AQUIND INTERCONNECTOR

Document Ref: 7.8.1

DATE: 6 OCTOBER 2020

Document	7.8.1 Environmental Statement Addendum
Revision	001
Document Owner	WSP UK Limited
Prepared By	C. Middleton, S. Lister, M. Boden, I. Ellis, Z. Norris, J. Chapman, J. Welbourn, J. Smith, C. Williams, S. Bennett, T. Farmer, J. Laver, C. Beard, K. Dean
Date	06 October 2020
Approved By	U. Stevenson
Date	06 October 2020

Plate 3.1 - Update of Plate 3.23 - Typical arrangement of HVDC and FOC cables in roads, verges and footpaths (all measurements in mm)

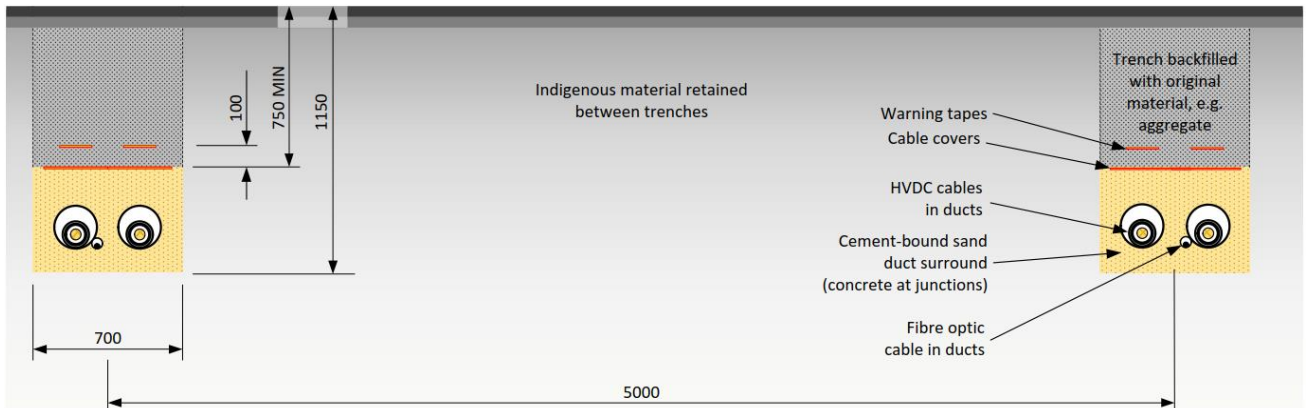
Plates 3.23 and 3.24 contained within Chapter 3 (Description of the Proposed Development) of the 2019 ES (APP-118) have been updated to clearly identify the FOC cable position within the duct, as shown in Plate 3.1 and 3.2 below respectively. Plate 3.1 also reflects a minor update to the depth to the bottom of the duct which has been updated to '1150 mm minimum' instead of 1250 mm as shown in the 2019 ES; this has no impact on the outcome of any of the assessments undertaken.

Plate 3.2 - Update of Plate 3.24 - Typical arrangement of HVDC and FOC cables in non-highway land (all measurements in mm)

Plate 5.1 - Thermal plot of heat emissions from Marine Cables at 1.5 m burial depth (the green line denotes the surface of the seabed)

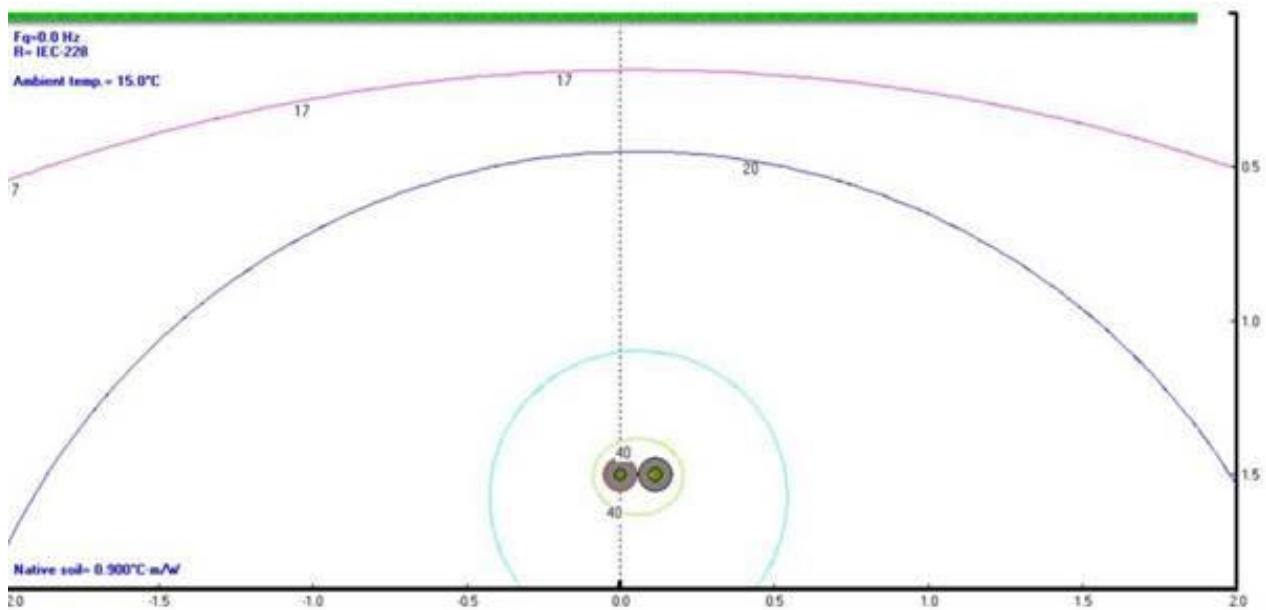
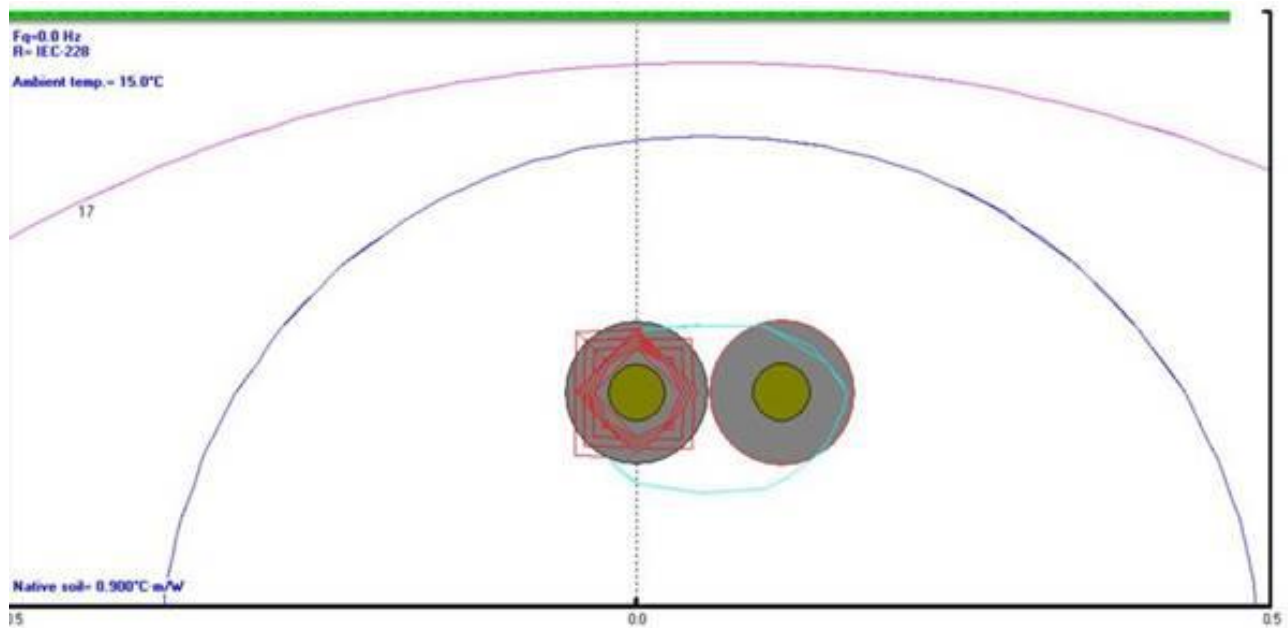
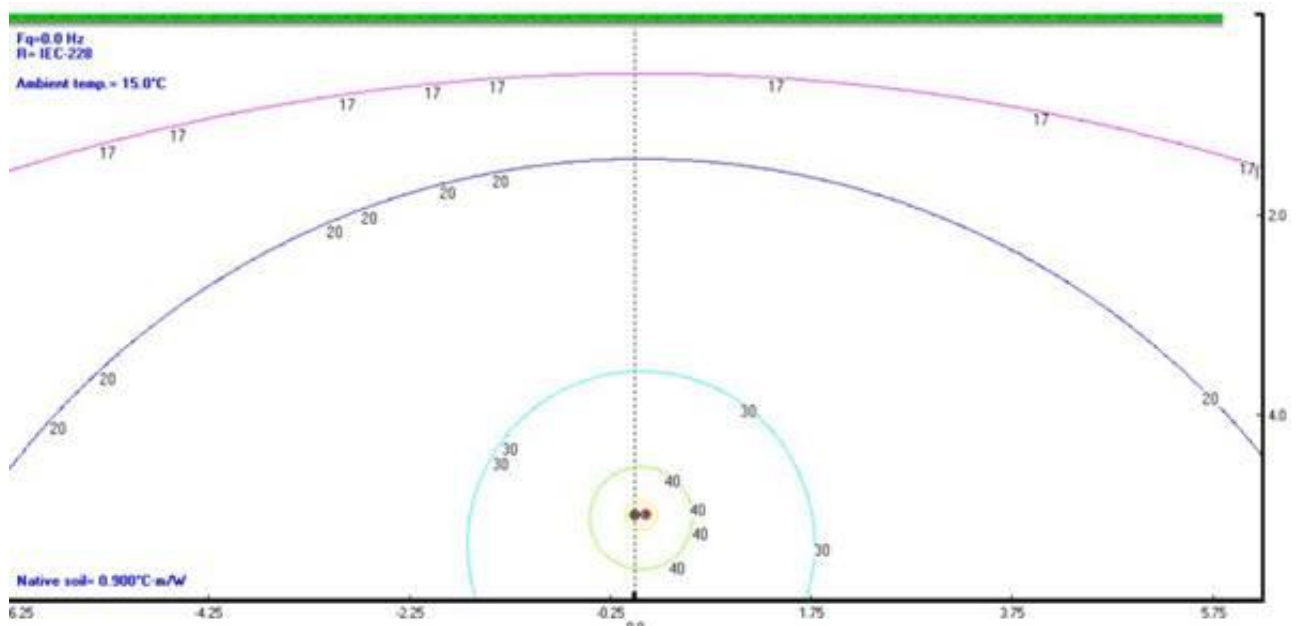
- 5.2.1.3. In the ExQ1, the ExA has queried this worst-case parameter used for heat and in ME1.10.28, requests the following:
- “Can the Applicant provide the worst-case scenario for cable overheating, what temperatures might be reached in the surface sediments and seawater immediately above, and how the surrounding habitats, wildlife and environment would be affected.”*

- 5.2.1.5. Plates 5.1 and 5.2 illustrate the thermal plot outputs from the modelling assessment of cables buried at 1.5 m (Plate 5.1) and 0.3 m (Plate 5.2). The plots reveal that at an ambient temperature of the surrounding environment of 15°C, the 17°C isotherm is below the surface of the seabed, so the ambient temperature rise at the level of the seabed due to the Marine Cables, is less than 2°C. This is the case for both cable burial depths of 1.5 m and 0.3 m. In the latter case, as 0.3 m depth has not met target burial depth for the cable, then it would also be expected that some form of additional cable protection (e.g. mattresses or rock) would be placed over the Marine Cables.

- 5.2.1.6. These thermal plots reveal that under normal operations, regardless of whether the cable is buried at 1.5 m or 0.3 m, the expected temperature rise at the seabed surface, will be 2°C or less. This illustrates that although an increased burial depth causes an increase in cable temperature immediately surrounding the cable, in deeper burials the increased distance to the seabed surface results in no greater warming at the seabed surface.

- 5.2.1.8. In terms of overheating, Marine Cables would not be buried at such depths that would result in excessive heat build-up in the conductors as this would be contrary to the optimal operation of the interconnector. Gradual heat increases in the Marine Cables are more likely to result from a change in thermal environment than other factors, e.g. the depth of cover increasing due to sandwave build up over the cables. Any heat

Plate 8.1 - Military vessels entering and leaving Portsmouth – six months AIS

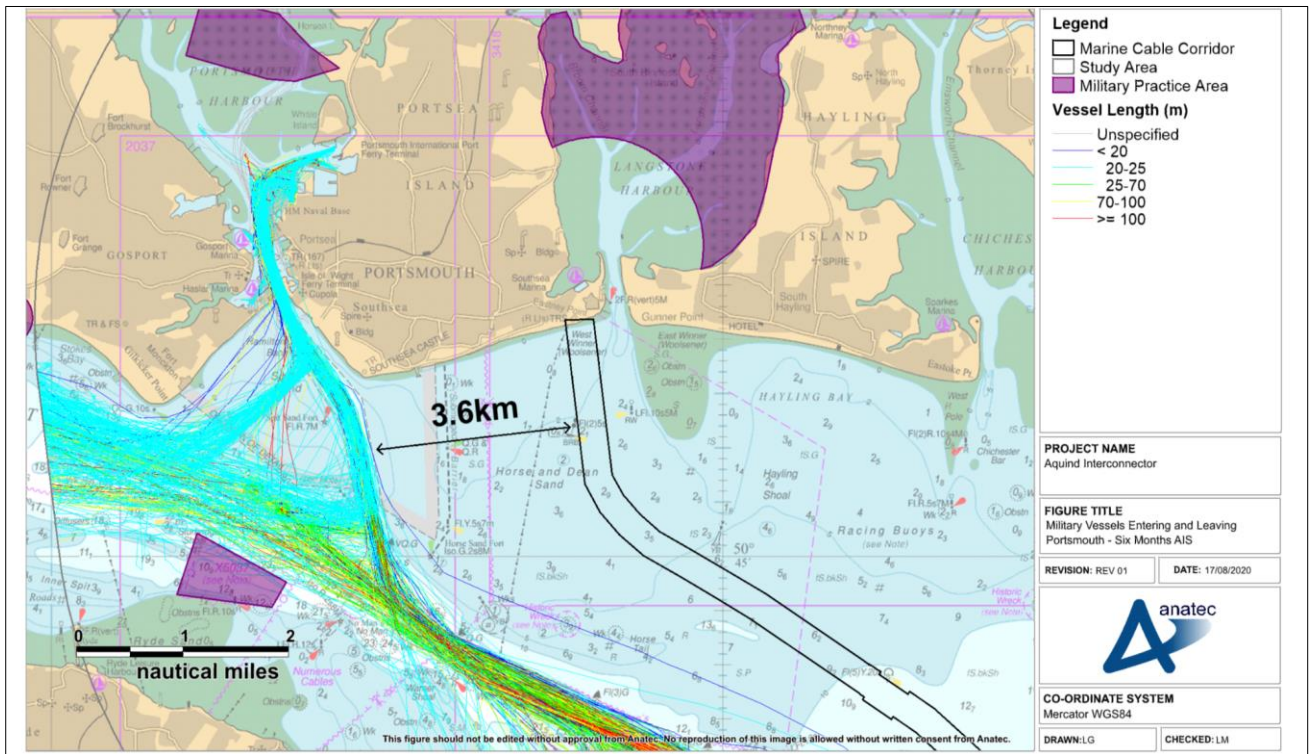
- 8.1.1.1. Following submission of the Application, the Applicant received the ExQ1 prior to the Examination period commencing. In response to a request by the ExA [SN1.14.1], supplementary information in regard to potential impacts resulting from the Proposed Development on military vessels and urgent military need has been provided.

It can be seen in Plate 8.1 that military vessels maintained a distance of approximately 3.6 km (2 nautical miles) from the Marine Cable Corridor on departure from Portsmouth. Vessels tend to follow the channels through the Solent and therefore this distance reduces as they travel further south. Plate 8.2 presents the military vessels transiting through the Solent, colour-coded by vessel length.

Plate 14.2 - Plan showing Option A footprint (*EN020022-2.10-EL-Sheet3*)

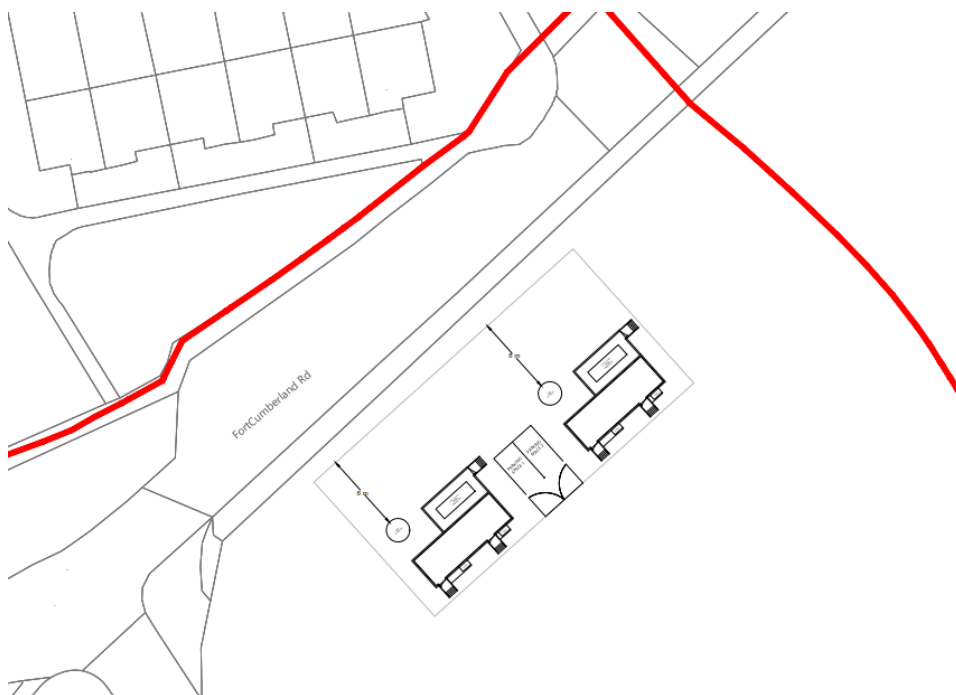
- **Figure 5a - Option A Level 1 Wireline** (Appendix 10 (document reference 7.8.1.10)), showing extent of building and roofline based on indicative plan *EN020022-2.10-EL-Sheet3* (see Plate 14.2);
- **Figure 5b - Option B Level 1 Wireline** (Appendix 10 (document reference 7.8.1.10)), showing extent of building and roofline based on indicative plan *EN020022-2.10-EL-Sheet4* (see Plate 14.3);
- **Figure 5c - Option A Level 2 Block** (Appendix 10 (document reference 7.8.1.10)), rendered 'level 2 block', showing likely extent and massing of single option placement, based on *EN020022-2.10-EL-Sheet3* (see Plate 14.2); and
- **Figure 5d – Option B Level 2 Block** (Appendix 10 (document reference 7.8.1.10)), rendered 'level 2 block', showing likely extent and massing of single option placement, based on *EN020022-2.10-EL-Sheet3* (see Plate 14.3).
